Silver Composite Textile Mills Ltd. (Extension)

7 October 2025

2. Observation

Observation-01: Applicable building code consideration in the design report (Garments Building-2, Connecting Bridge, Boiler Building).

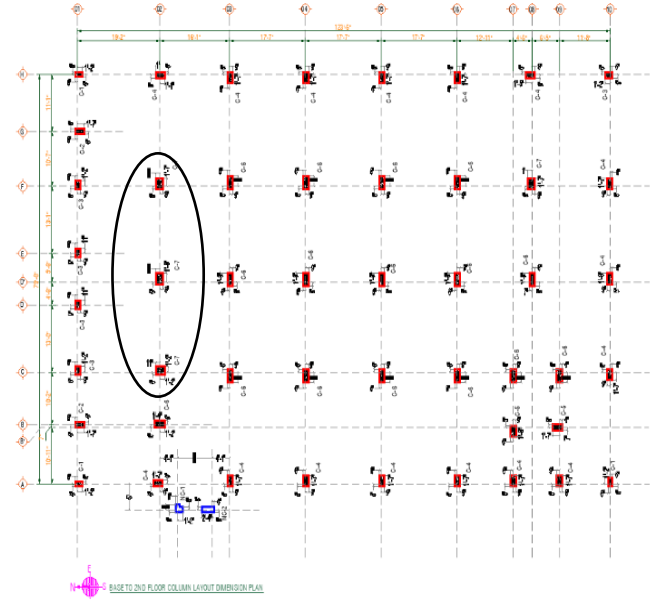
Description: A set of design documents were prepared for the structures considering BNBC 2006. However, the structures were permitted by local authority LGED [Gazipur Sadar] dated January-2022 and the structures were constructed after February-2021. So, BNBC 2006 may not be applicable here.

Building engineer is required to review the construction history and building permits and applicability of design code. Also, the building engineer is required to prepare the design report in compliance with the BNBC code.

Item No	Observation	Action Plan	Timeline
1.	Applicable building code consideration in the design report (Garments Building-2)	The building engineer is required to review the construction history and building permits and applicability of design code.	within 6 weeks

2.		The building engineer is required to prepare the design report including External RC Stair in compliance with the BNBC code.	within 6 weeks
3.		Implement the recommendations of the design report.	within 6 months

Observation-02: Mismatch/incomplete as-built drawing for Garments Building-2, Security Control Room and Fire Pump House.

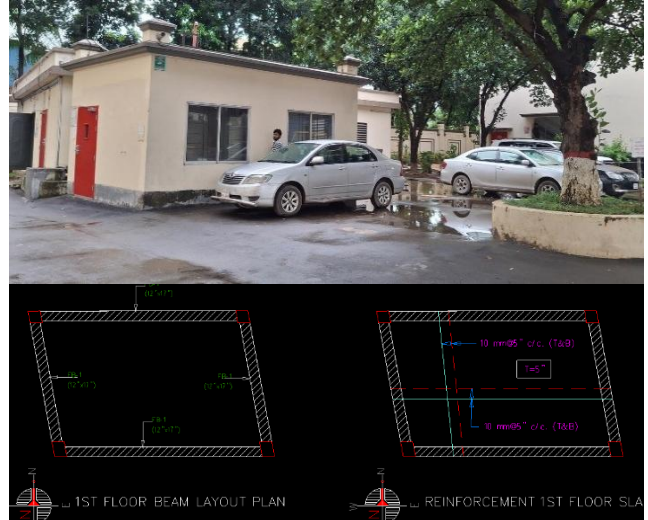
Garments Building-2: Total 18 re-bars were found by scanning instead 20 re-bars in C7 column.

Security Control Room: Beam not found in the marked location

Description: The building engineer is required to survey the structure and prepare as-built drawings with necessary details.

Fire Pump House: Column C2 detailing and roof beam-slab dimension-detailing were incomplete.

4.	Mismatch in the as-built drawing for Garments Building-2	The building engineer is required to survey the structure for (floor occupancy & column schedule) and prepare accurate as-built drawings.	within 6 weeks

Observation-03: Lack of load management system and change of floor use (Garments Building-2, Fire Pump House)

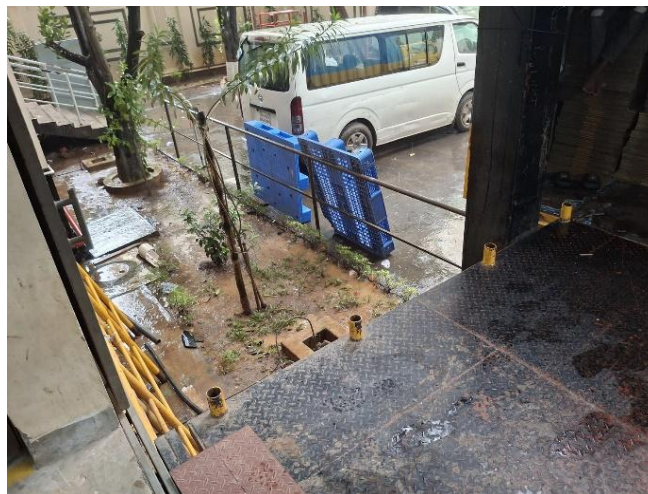
Description: Storage observed on typical floor for Garments Building-2 and car parking on top slab of UGWR. The building engineer is required to post updated floor load plans on each floor/parking area, provide storage area & height marking and maintain floor loading accordingly.

5.	Lack of load management system and change of floor use (Garments Building-2)	The building engineer is required to post updated floor load plans on each floor, provide a storage area & height marking and maintain floor loading accordingly.	within 6 weeks

Observation-06: Roof drainage system (Garments Building-2)

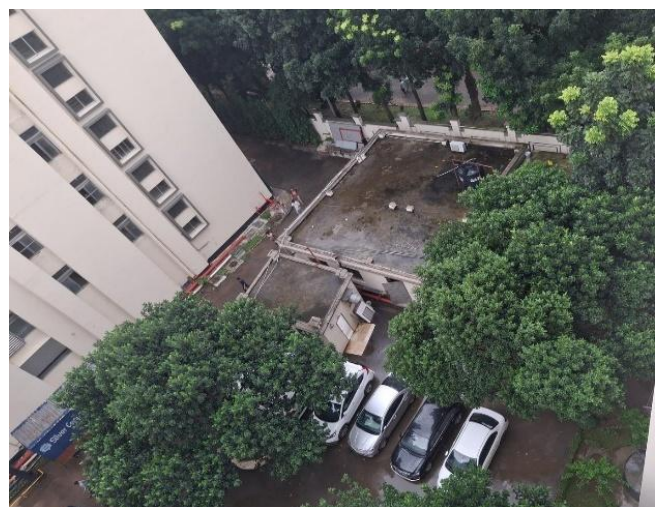
Description: Slightly water ponding observed on the roof. The building engineer is required to improve the roof drainage system with an adequate slope.

7.	Falling hazard at the elevated platform (Garments Building-2)	Provide adequate edge protection to prevent the risk of falls.	within 6 weeks
8.	Roof drainage system (Garments Building-2)	The building engineer is required to improve the roof drainage system with adequate slope.	within 6 months

Observation-08: Revision of design documents for lateral loads (Fire Pump House)

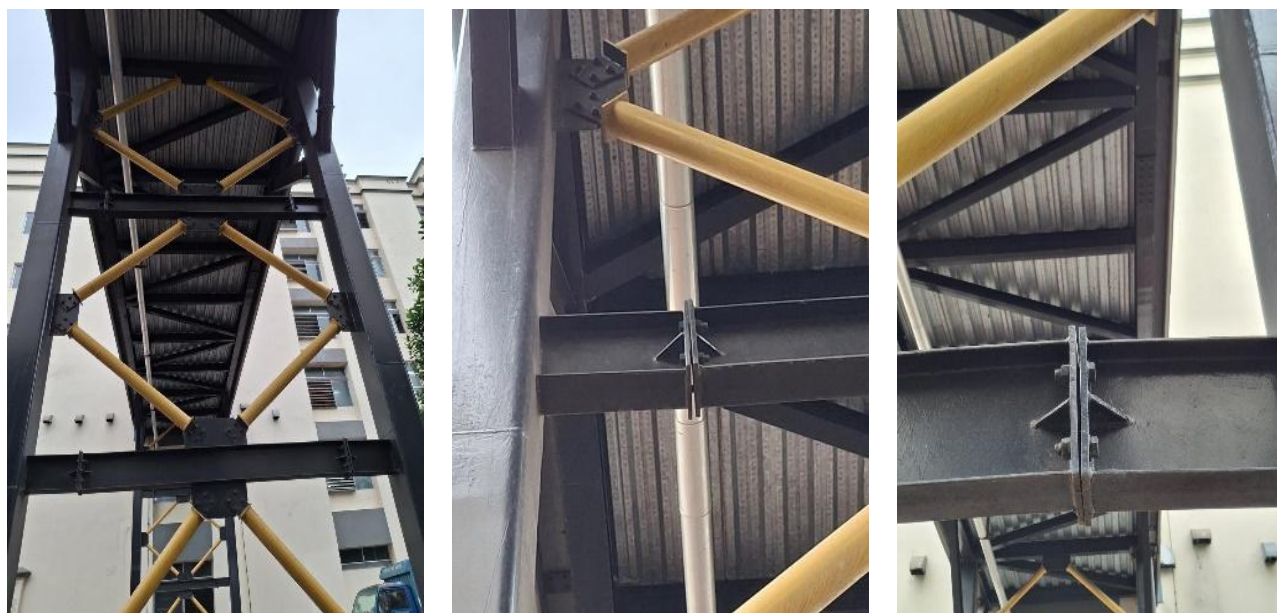
Description: A set of design documents was available. The building engineer is required to update the design documents and submit to RSC for detailed review against lateral forces.

13.	Revision of design documents for lateral loads. (Fire Pump House)	The prepared design report needs to be reviewed against lateral forces. Submit the design report to the RSC for detailed review.	within 6 weeks
